**Subject:** Duke Energy Carolinas, LLC  
Oconee Nuclear Station, Units 1, 2, and 3  
Docket Numbers 50-269, 50-270, and 50-287,  
Renewed Operating Licenses DPR-38, DPR-47, and DPR-55  
Licensing Basis for the Protected Service Water System - Responses to  
Request for Additional Information - Supplement 1

Duke Energy Responses to RAI Items

RAI #125 (page 1 of 9):

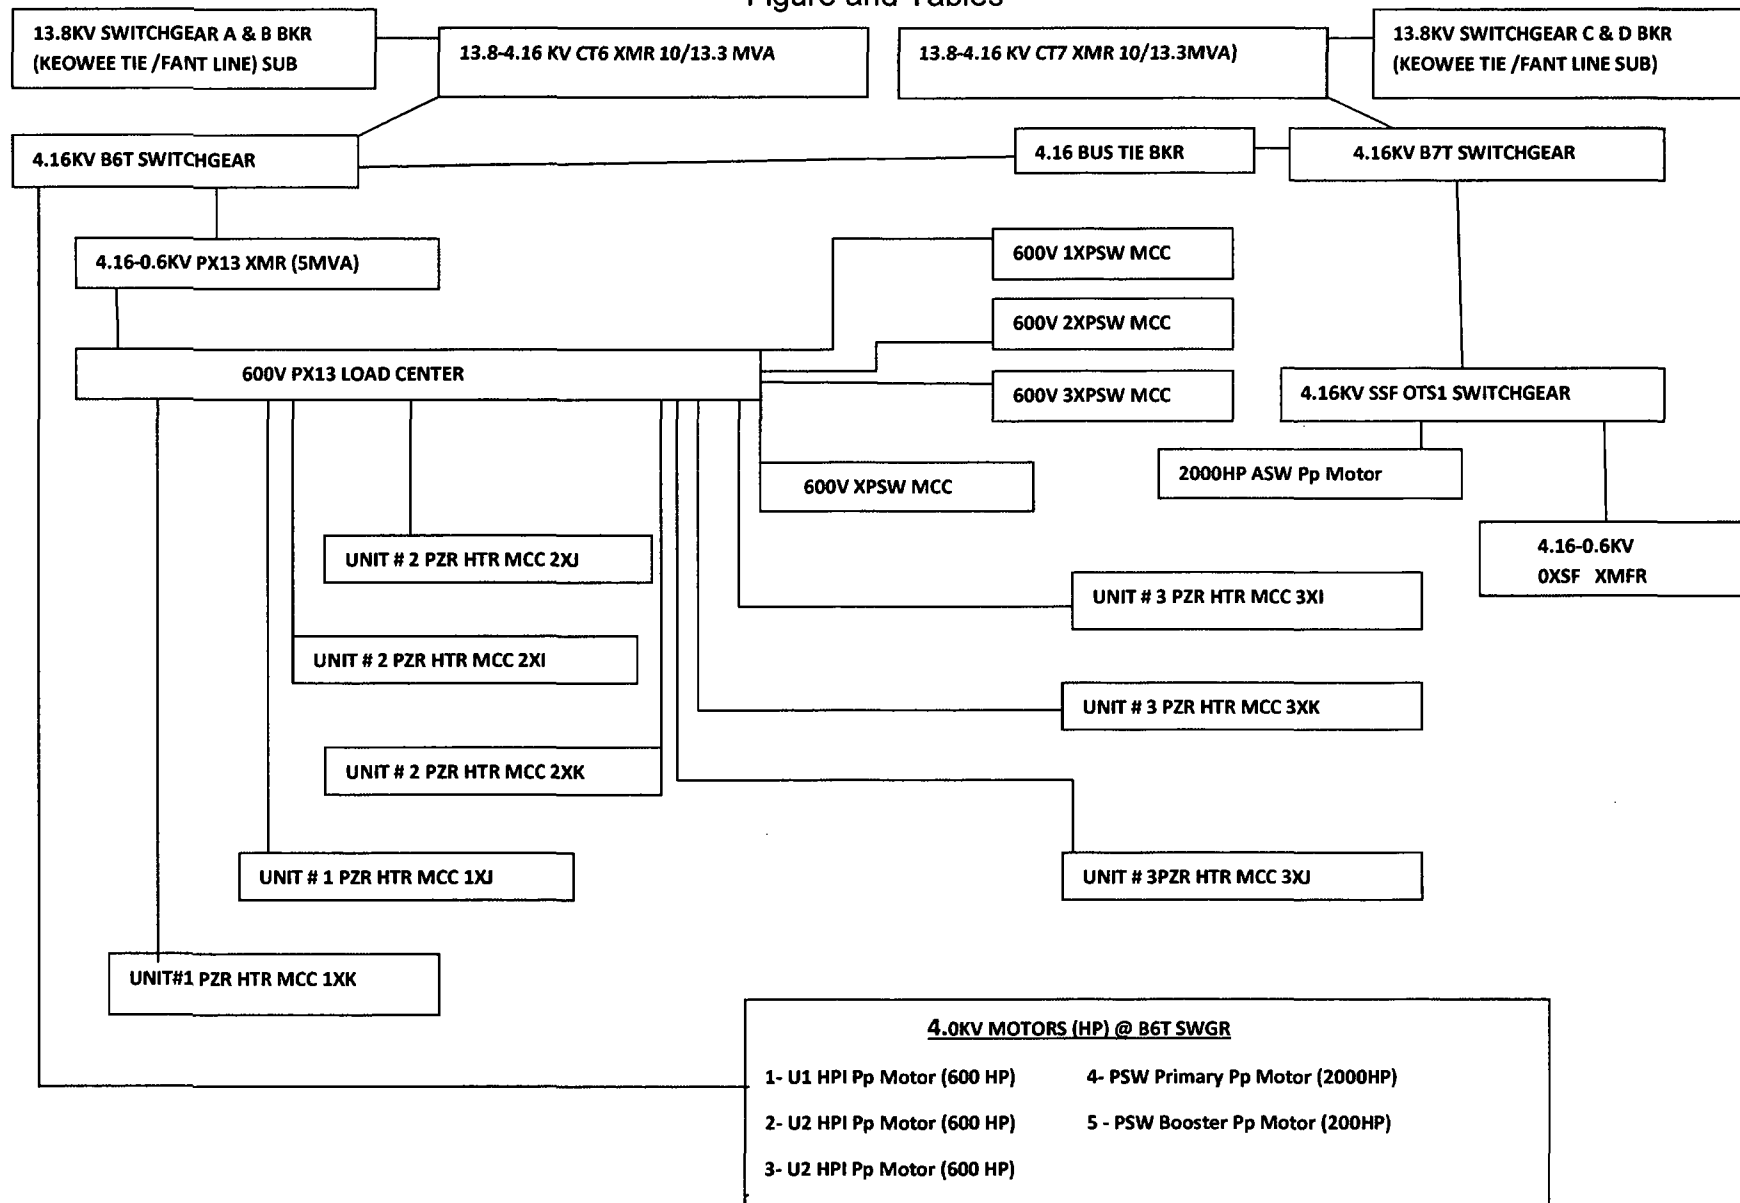
In a letter dated December 16, 2011, enclosure 3, tab 2, in response to RAI 43, the licensee referenced its submittal dated August 31, 2010, and a previous RAI 2-27. In its August letter, the licensee stated that the loading on the PSW transformer, switchgears, and load centers will be answered in a future RAI response submittal. However, the staff's review of the licensee's responses dated December 7, 2010, December 16, 2011, and January 20, 2012, did not find any discussion regarding equipment loading. Provide a table showing the PSW system worst case electrical loadings at 13.9 kV, 4.16 kV, and 600 V buses, and all equipment, bus, and breaker design ratings demonstrating that the worst-case loadings are within the design rating of the associated equipment/bus/breaker.

A sketch and applicable tables listing electrical equipment loading versus equipment ratings for PSW 13.8 KV, 4.16 KV and 600 V buses is provided in the RAI #125 supplemental information section of the Attachment to this letter. The data in the tables is based on current PSW design information. While some of the values may change minimally with design completion, the Duke Energy QA Program and associated design processes ensure that potential nonconformances with equipment design ratings will be resolved prior to placing the equipment in service.

Figure 160.1

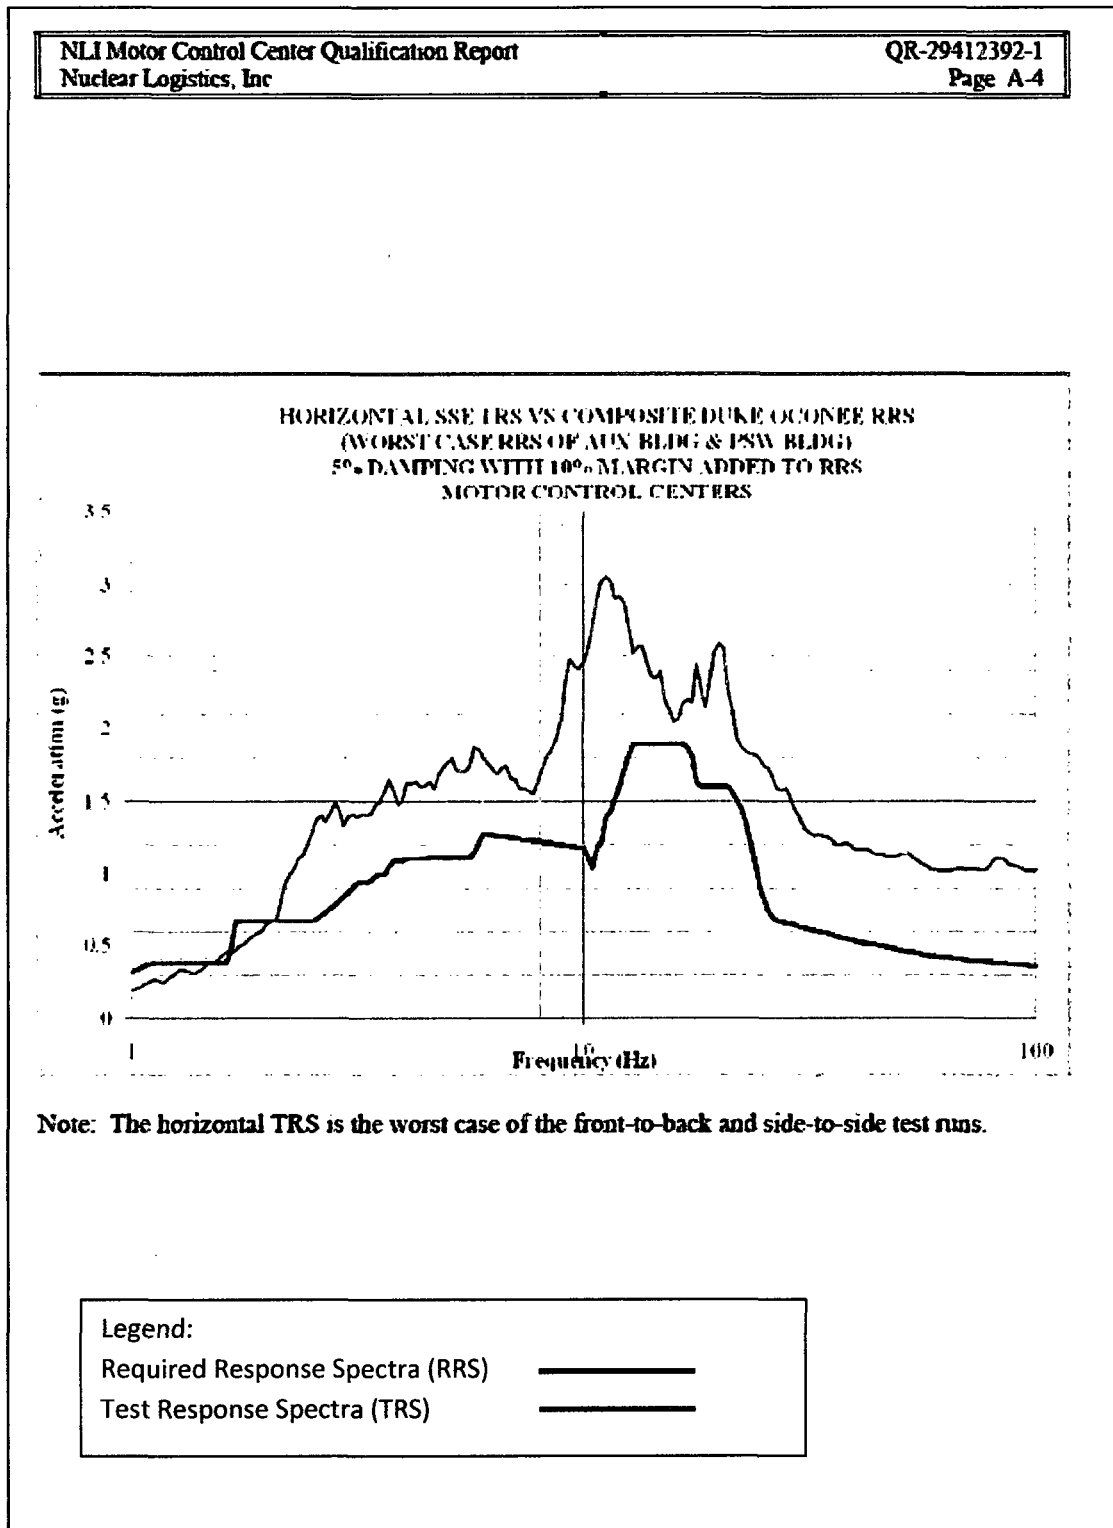
In response to RAI-62, the licensee included, in its letter dated January 20, 2012, Institute of Electrical and Electronic Engineers (IEEE) 344-1975 as one of the industry standards that is being used for the PSW system design. Discuss the seismic qualification method(s) used for electrical and mechanical equipment credited for the PSW system. Provide a summary of the seismic qualification results to demonstrate that all equipment credited for the PSW system including their subcomponents (relays, contacts, breakers etc.) are capable to perform their intended design function in the event of a safe shutdown earthquake (SSE) after a number of postulated occurrences of the operating basis earthquake (OBE). The response to this RAI, as a minimum, should include the test response spectra (if applicable), the required response spectra, the method of mounting of equipment to the shake table, and the equipment mounting configuration in service condition. Also, discuss the methodology, the industry codes and standards, the level of earthquake, and the acceptance criteria used for the structural design of the PSW equipment mounting.

A comparison of the Test Response Spectrum (TRS), obtained from the control accelerometers, to the RRS for the SSE is shown in Figures 160.1 and 160.2 for the horizontal and vertical excitation directions respectively (Note: Figures 160.1 and 160.2 are provided in the RAI #160 supplemental information section of the Attachment to this letter).
